# HISTORIC AND DESIGN REVIEW COMMISSION

February 15, 2023

**HDRC CASE NO:** 2023-038  
**ADDRESS:** 202 N ST MARYS ST  
130 N ST MARYS ST  
**LEGAL DESCRIPTION:** NCB 405 BLK LOT N 109.8 FT OF 1 & 2  
NCB 405 (SAA- OMI TRACT), LOT 10  
**ZONING:** D, HE, RIO-3  
**CITY COUNCIL DIST.:** 1  
**LANDMARK:** Individual Landmark  
**APPLICANT:** Anthony Byron  
**OWNER:** St Mary's Catholic Church  
**TYPE OF WORK:** Construction of a 17-story hotel tower  
**APPLICATION RECEIVED:** January 31, 2023  
**60-DAY REVIEW:** Not applicable due to City Council Emergency Orders  
**CASE MANAGER:** Edward Hall  
**REQUEST:**

The applicant is requesting a Certificate of Appropriateness for approval to construct a hotel tower to feature seventeen stories, not including the river level, to feature an overall height of approximately 203 feet. The proposed hotel received final approval in May 2019 but has since been amended regarding height.

St Mary's Riverwalk Landscape Sections

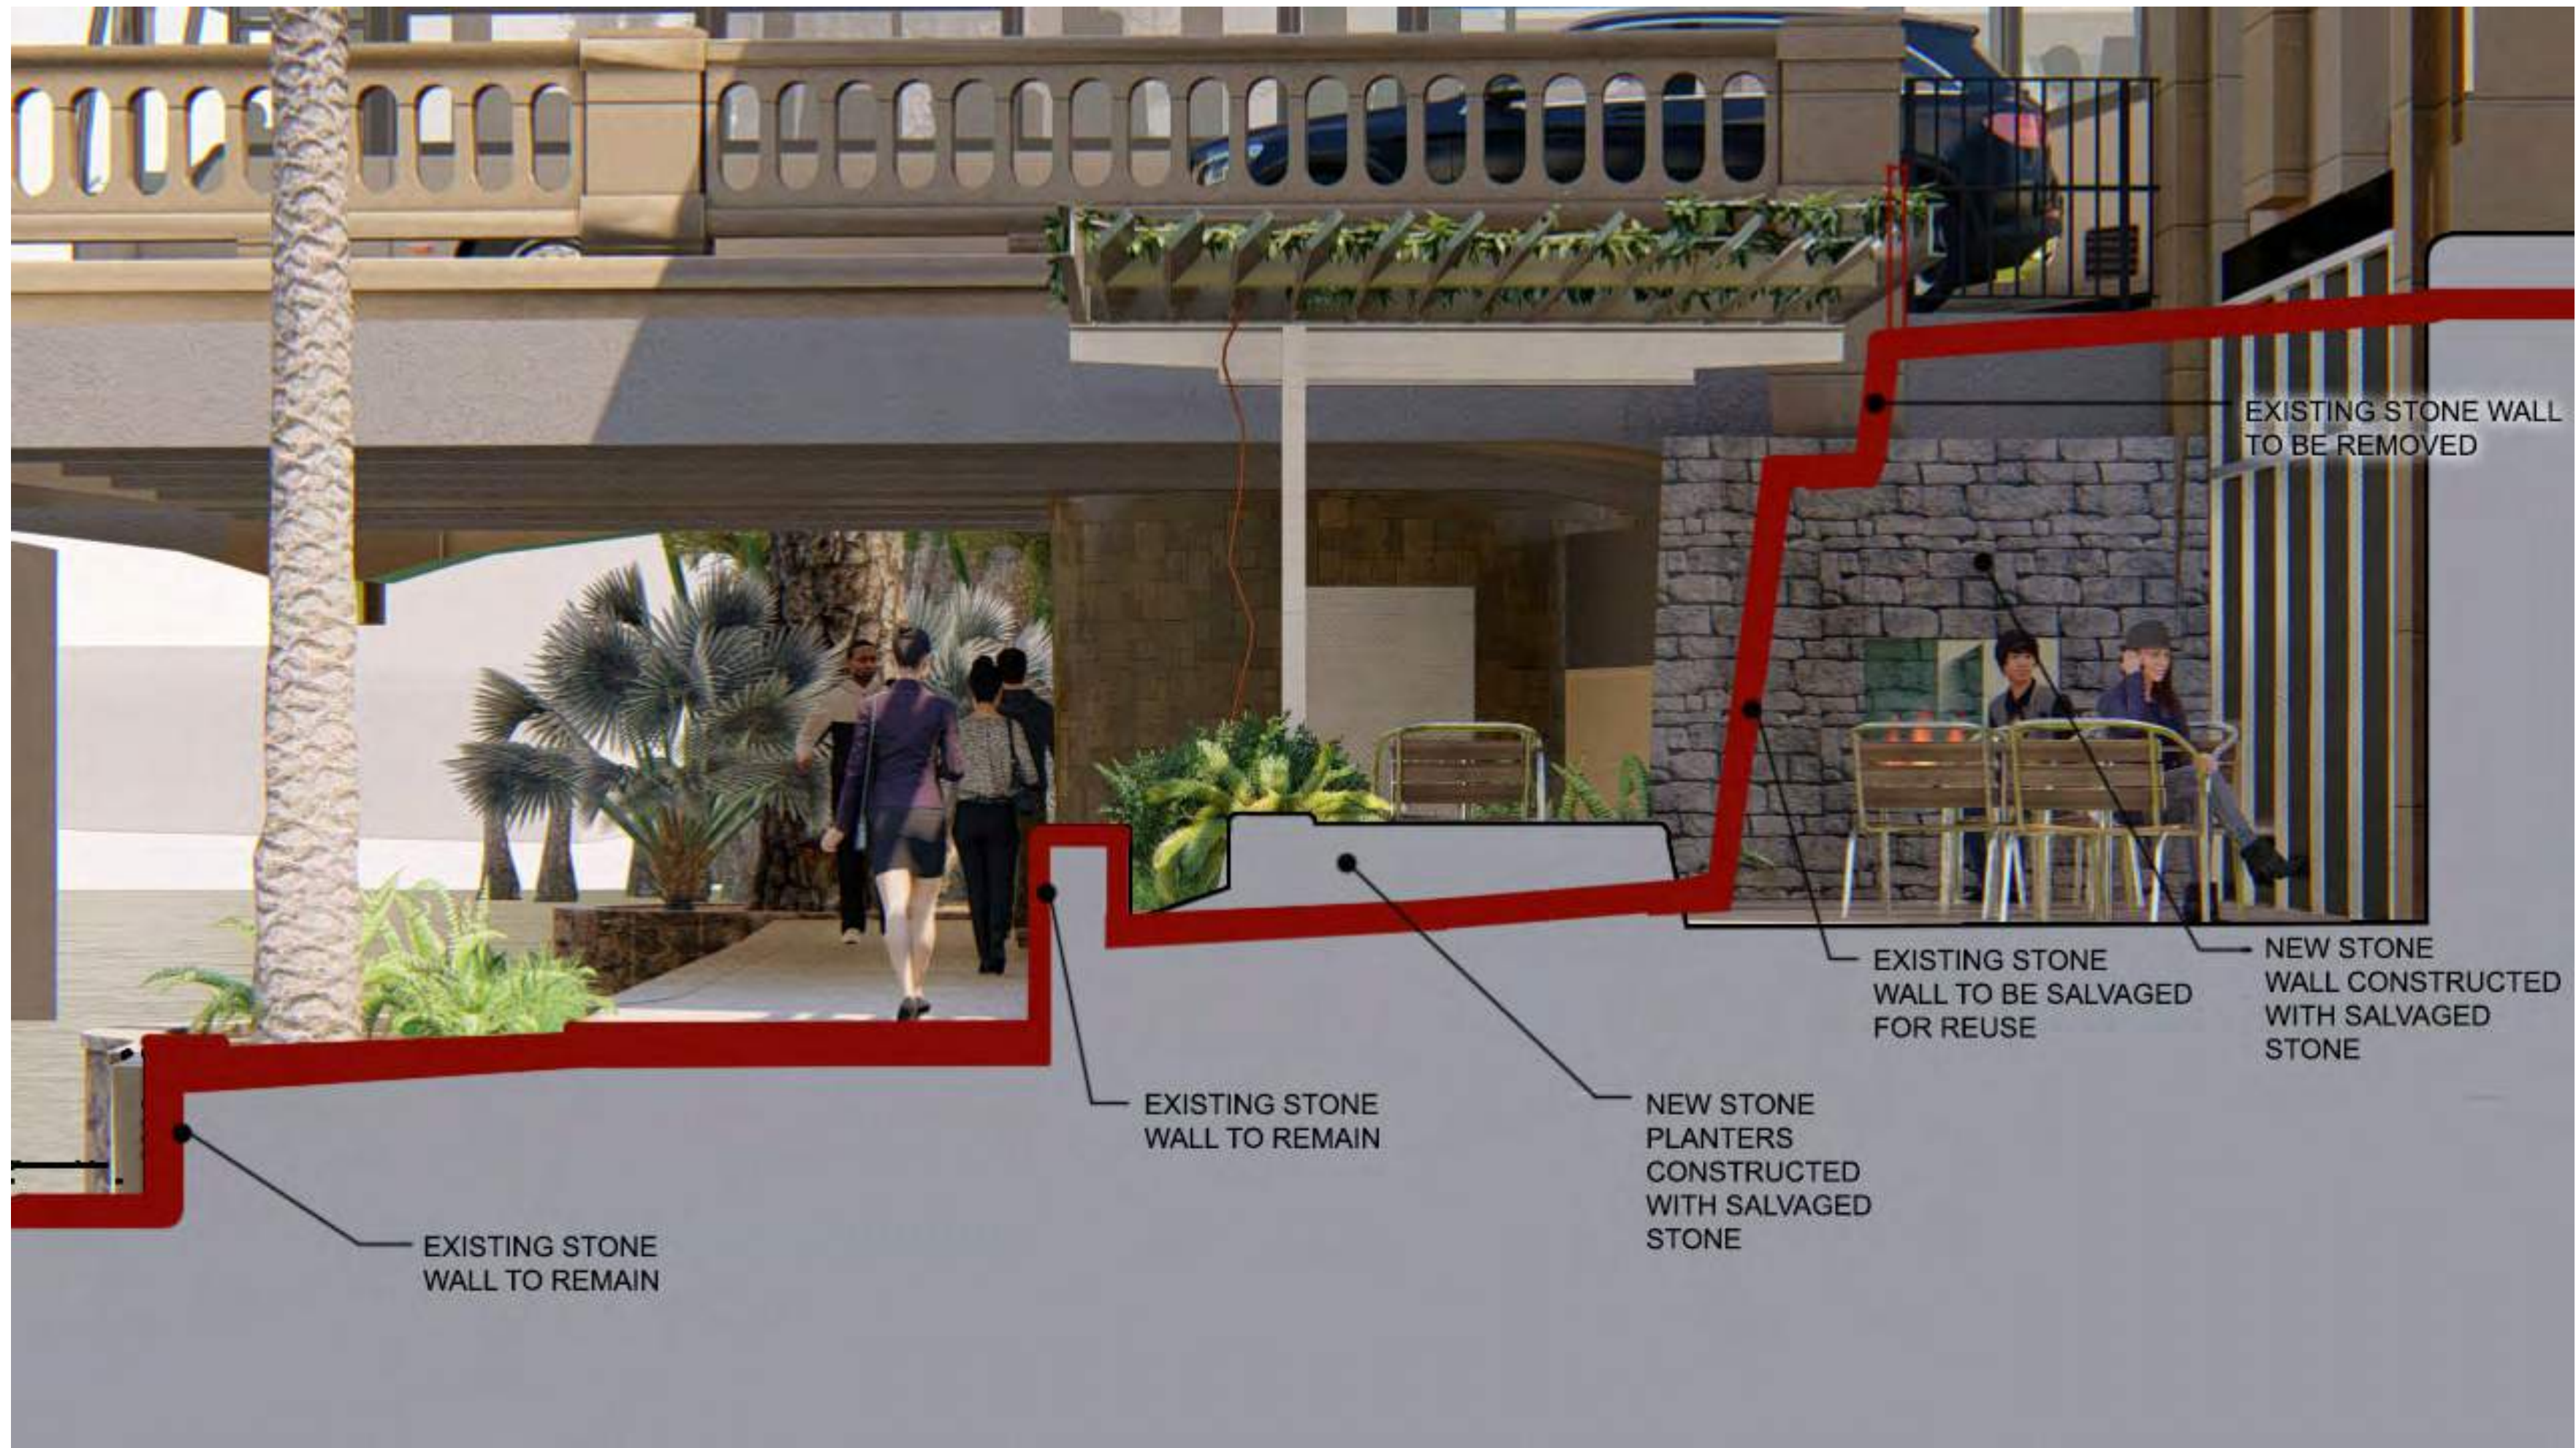
- i. That a salvage and reuse plan for existing stone elements must be provided as part of the final landscaping plan. *This stipulation has been met.*
